**APPLICATION FOR PERMISSION
UNDER SECTION 16 OF
THE TOWN PLANNING ORDINANCE
(CAP.131)**

Proposed Temporary Training Facilities in San Tin**Application for Permission under Section 16 of the Town Planning Ordinance**

Planning Application No. A/YL-ST/658
Agreement No. CE47/2020 (CE) – Term Consultancy for Site Formation and
Infrastructure Works for Proposed Housing Developments in Zone 2 (2021-2024) –
Feasibility Study, Task Order No. 9 – San Tin
(Application for Permission under S.16 of the Town Planning Ordinance)

Drawing Title
TASK ORDER NO. 9 - SAN TIN
EXISTING SEWERAGE LAYOUT
PLAN

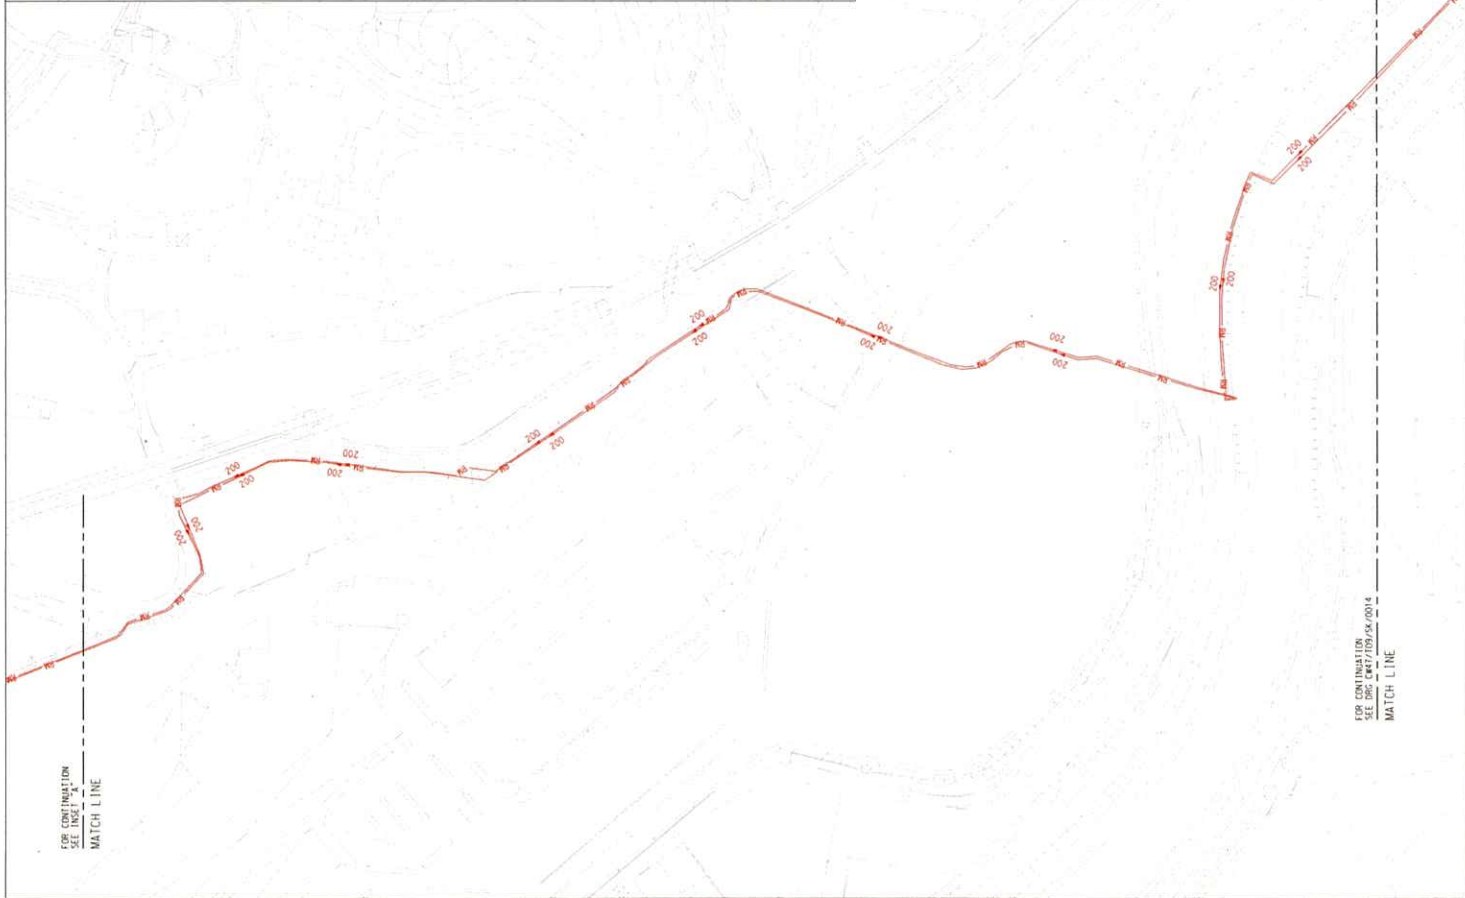
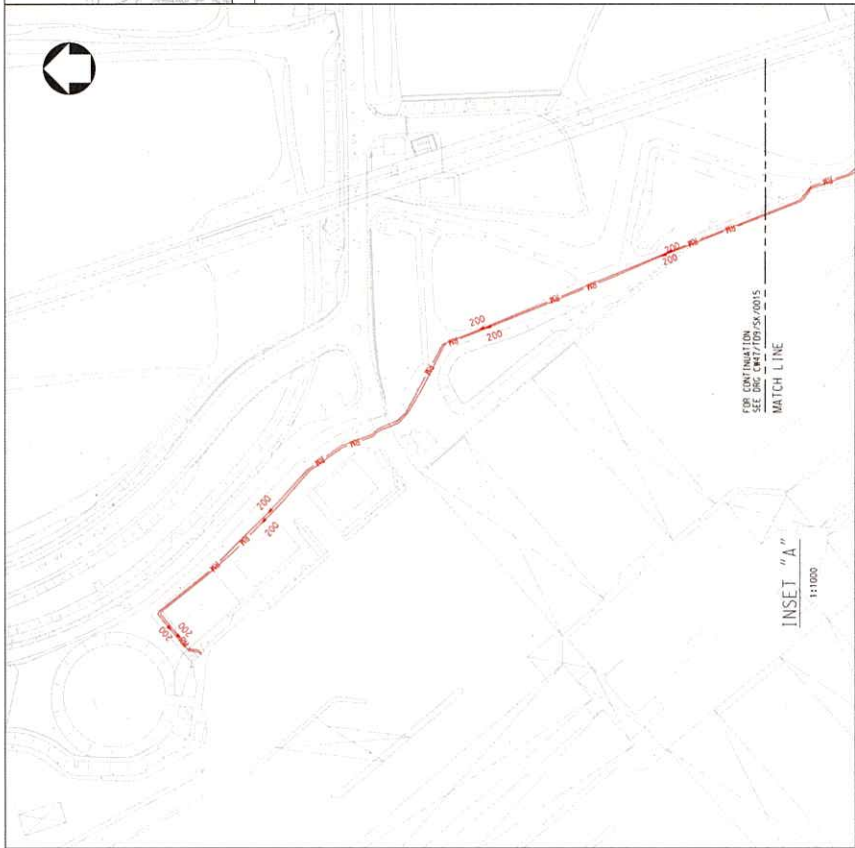
| 11 | <p>Drawing: Please show the entire route of rising mains for clarity.</p> | Noted, the existing sewerage showing the entire route of the rising mains are now shown in the attached existing sewerage layout plans (Appendix B). |

| Drawing No. | FIGURE 4.3a | Rev | |

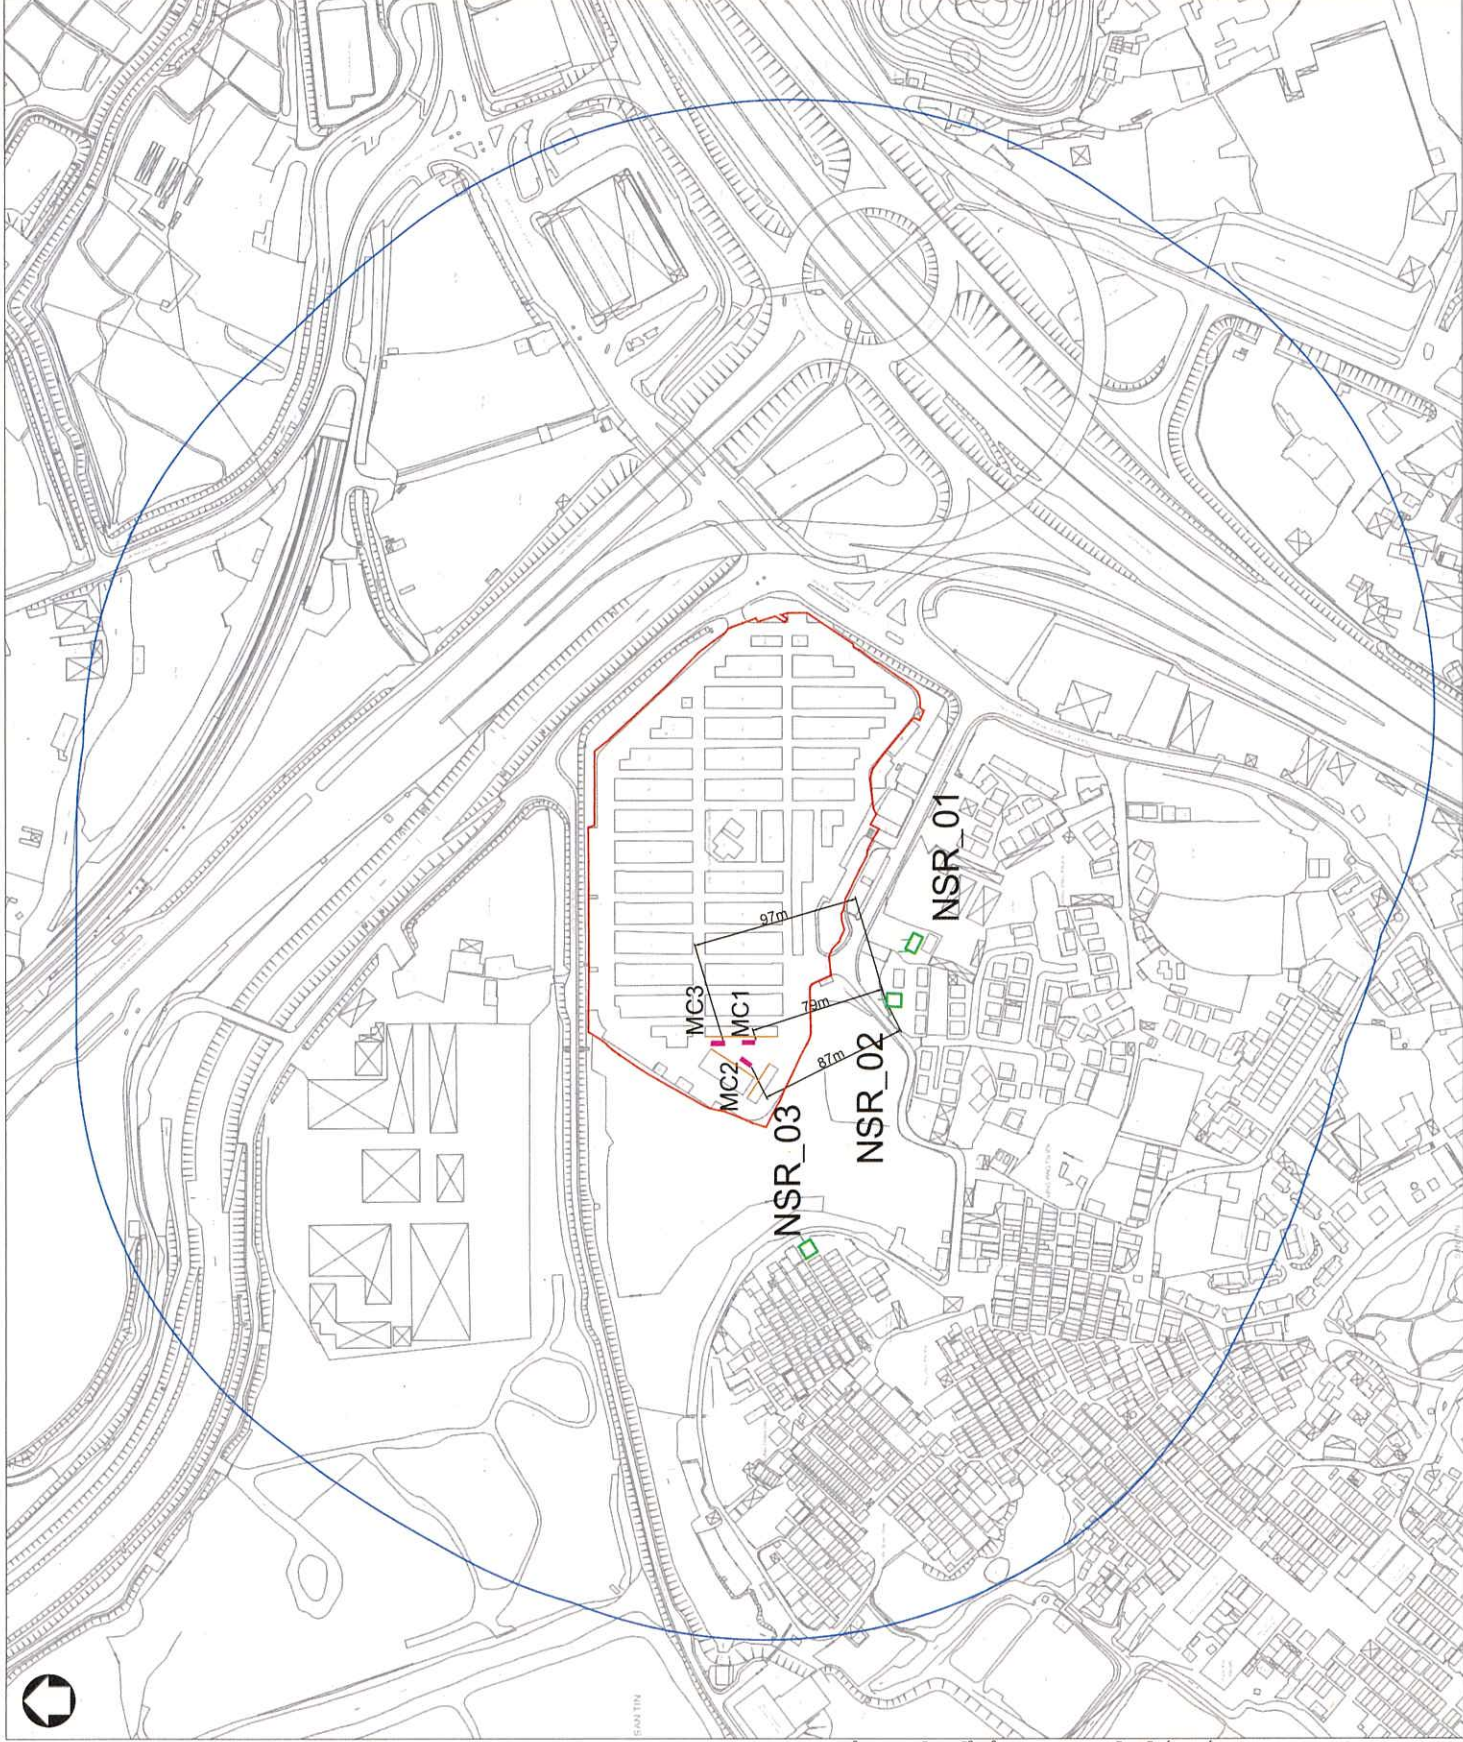
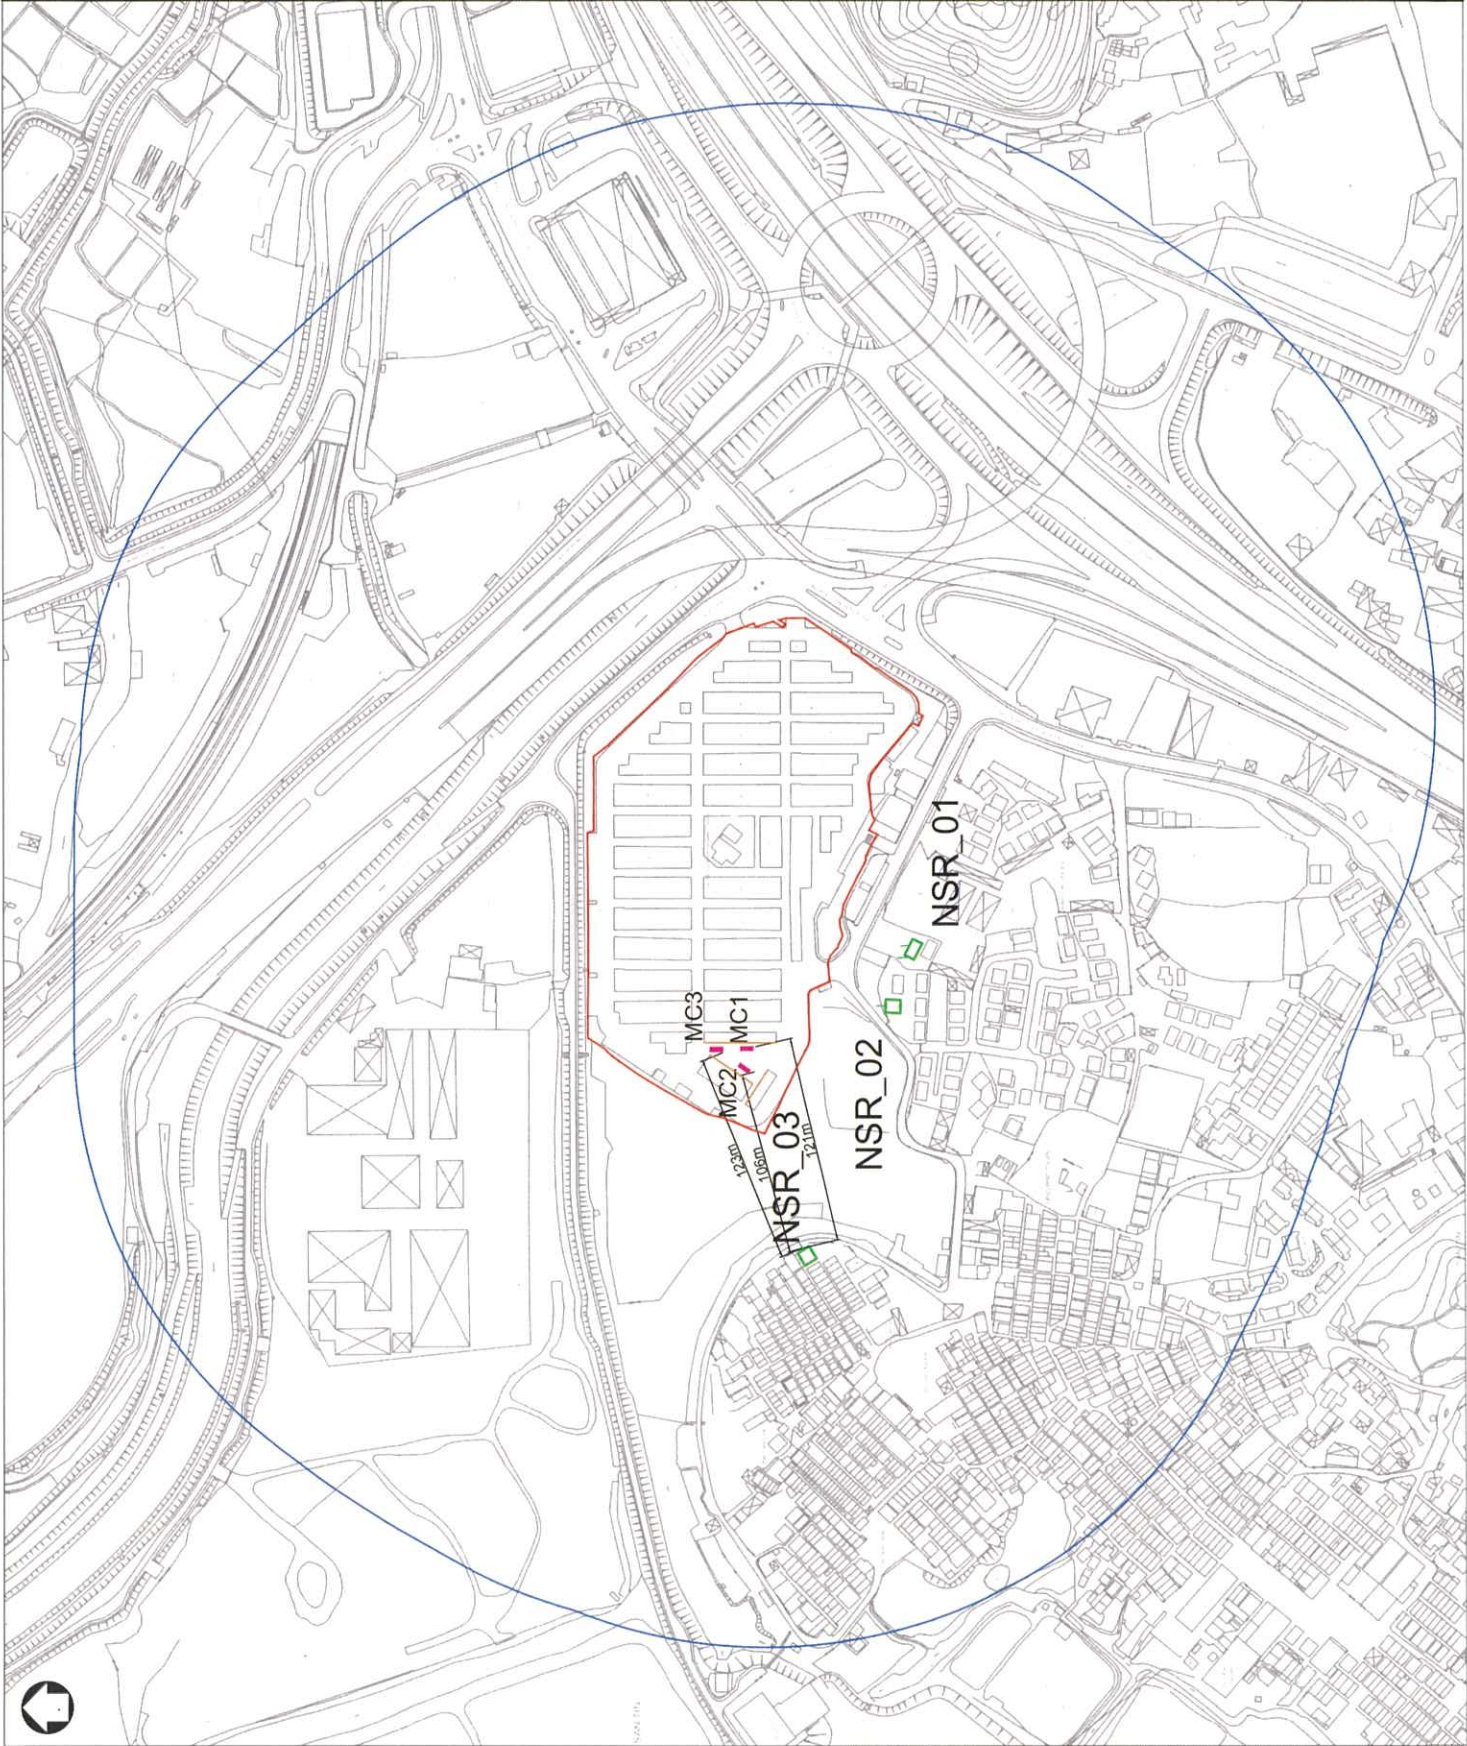
| 2 | Figure 4.3a – 4.3b: For the horizontal distances shown in these figures, all the “mm” s should be revised to “m”. | Revised Figure 4.3a – 4.3c |

| 2 | <p>Table 4.8</p> <p>Due consideration should be given to the potential degradation caused by the reflections/reverberations of noise between the existing CIF buildings, and sound absorptive materials should be fitted/provided on the buildings' surfaces to minimize the impact. Please review and supplement this consideration in the ERR. The locations of the sound absorptive materials to be used should also be shown in a suitably scaled figure (i.e., Figure 4.3) for easy cross-referencing.</p> | <p>Section 4.5.21 is revised with updated Figures 4.3a to 4.3c.</p> |
